10 CFR 50.90
L-2014-236
July 24, 2014

Turkey Point Units 3 and 4
Docket Nos. 50-250 and 50-251
Renewed Facility Operating License Nos. DPR-31 and DPR-41

Subject: Response to Containment and Ventilation Branch Request for Additional Information, Regarding License Amendment Request No. 231, Application to Revise Ultimate Heat Sink Temperature Limit

**Response to Request for Additional Information from the
Containment and Ventilation Branch Regarding
Turkey Point Units 3 and 4
License Amendment Request No. 231
Application to Revise Ultimate Heat Sink Temperature Limit
Enclosure**

SCVB RAI-1 Figure 1

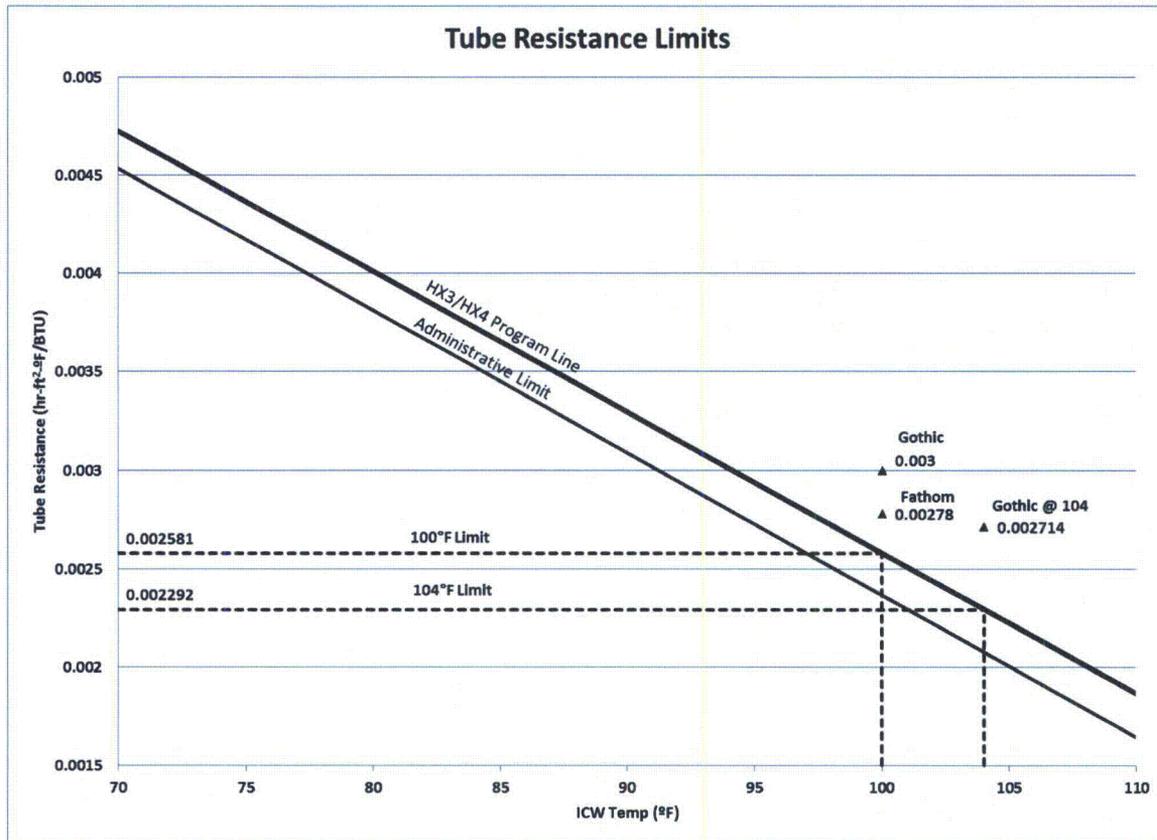
- A. Does the HX3/HX4 computer program replace the currently used GOTHIC methodology in the current licensing basis analysis? If so, please describe in detail how the HX3/HX4 computer program replaces the GOTHIC modeling to determine the revised CCW supply temperature to the ECCs and RHR HX, while considering the limiting values of all of the post-accident CCW HX heat loads. Please include the analysis inputs and assumptions used in the revised method justifying their conservatisms.

UFSAR Table 14.3.4.3-1, "Containment Analysis Parameters," currently states the intake cooling water (ICW) (UHS) temperature used for containment integrity is 100°F. The CCW heat exchanger heat removal capability is defined by the combination of the ICW temperature and the tube fouling factor (or tube resistance). The input values contained in the accident analysis calculations are 100°F ICW temperature and a corresponding 0.0030 hr-ft²-°F/BTU CCW heat exchanger fouling factor. The same heat exchanger heat removal capability assumed in the accident analysis can be assured with a higher ICW temperature by maintaining a lower tube fouling factor. The HX3/HX4 computer program is used as part of the CCW heat exchanger surveillance and testing procedures to maintain the necessary level of cleanliness (below the administrative limit) to satisfy the required heat removal capability of the CCW heat exchangers. As can be seen, this value for the tube fouling factor assumed in the accident analysis is *higher than the tube fouling factor allowed by* the "HX3/HX4 Program Line" shown in the application (FPL letter L-2014-216) Figure 3.5-1 (included below as SCVB RAI-1 Figure 1). The surveillance and maintenance of the CCW heat exchangers assures that their heat removal capability remains conservatively bounding of that assumed in the safety analysis over a range of allowable UHS temperatures and associated tube resistance.

Figure 3.5-1 in the July 10, 2014 FPL application has a typographical error for the tube resistance at 100°F on the HX3/HX4 program line. SCVB RAI-1 Figure 1 replaces Figure 3.5-1. Additionally, the figure has been updated to provide additional clarifying information to assist the NRC staff in understanding the current analyses of record and the analyses performed for the RAI response. Specifically, the original point labeled as safety analyses is clarified to reflect that it is the AFT Fathom thermal-hydraulic model. The assumptions used in the GOTHIC analysis of record and the GOTHIC sensitivity studies in the response to this RAI are also included.

SCVB RAI-1 Figure 2

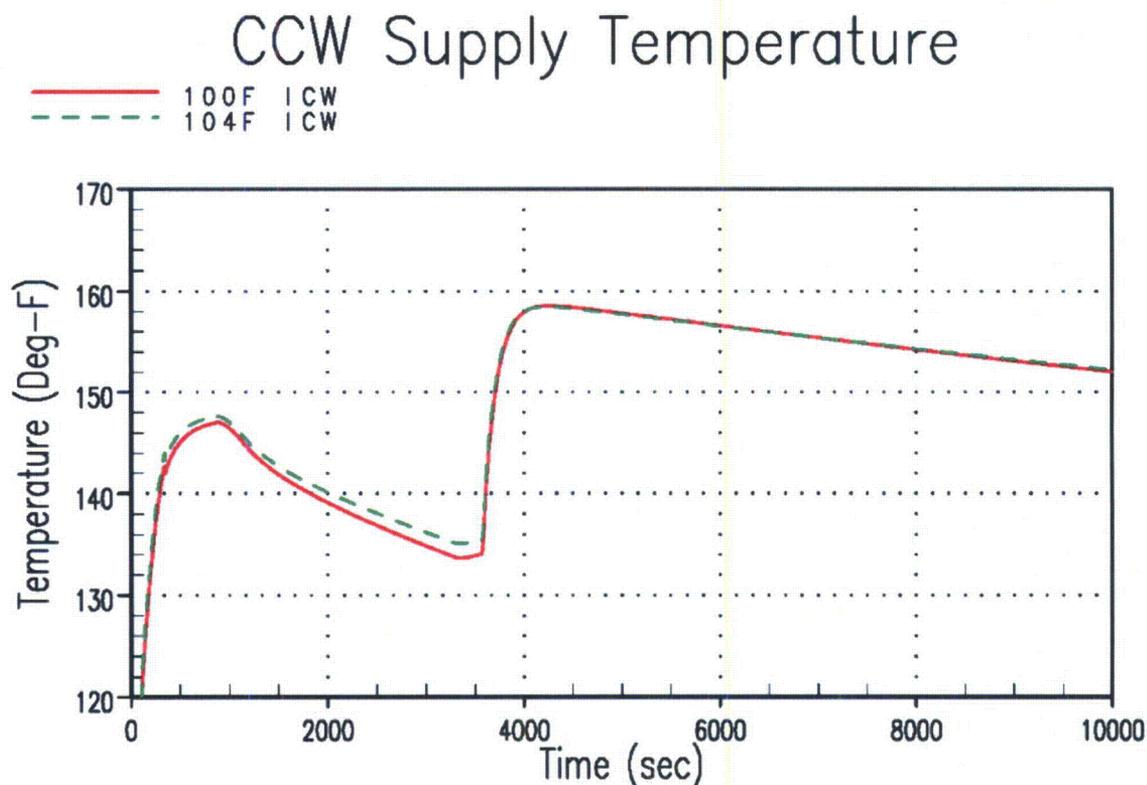
- B. Using the current GOTHIC model and the proposed ICW water temperature of 104°F as input, provide the CCW supply water temperature profiles to the ECCs and RHR HX for the limiting Double-Ended Pump Suction (DEPS) and Double-Ended Hot Leg (DEHL) Break Loss-of-Coolant Accidents (LOCAs) and Main Steam Line Break (MSLB) accident, and provide the CCW peak temperature values. The analysis should be performed using the same inputs as in the current analysis, i.e., assuming the worst safety related equipment heat loads, while using the proposed improved CCW HX tube resistance. If any of the remaining inputs are revised, please justify.

SCVB RAI-1 Figure 2 presents the CCW supply temperature profile for LOCA. Although there are small temperature differences this temperature profile demonstrates the CCW heat removal performance remains essentially the same at 104°F ICW temperatures when the tube resistance is reduced to 0.002714 hr-ft²-°F/BTU.

ICW Temperature (°F)	100	104
Peak Containment Pressure (psig)	50.61	50.61
Peak Containment Temperature (°F)	275.8	275.8
Peak Sump Temperature (°F)	236.6	236.6
Peak CCW supply Temperature (°F)	158.6	158.5

As shown, there is no significant change in the peak values. Note, the inputs used for this case ensure CCW supply temperatures are maximized; however, this will result in a lower containment pressure because more heat is removed from containment and transferred into the CCW system. Nevertheless, a similar insignificant impact is expected for the UFSAR limiting containment response licensing basis analysis.
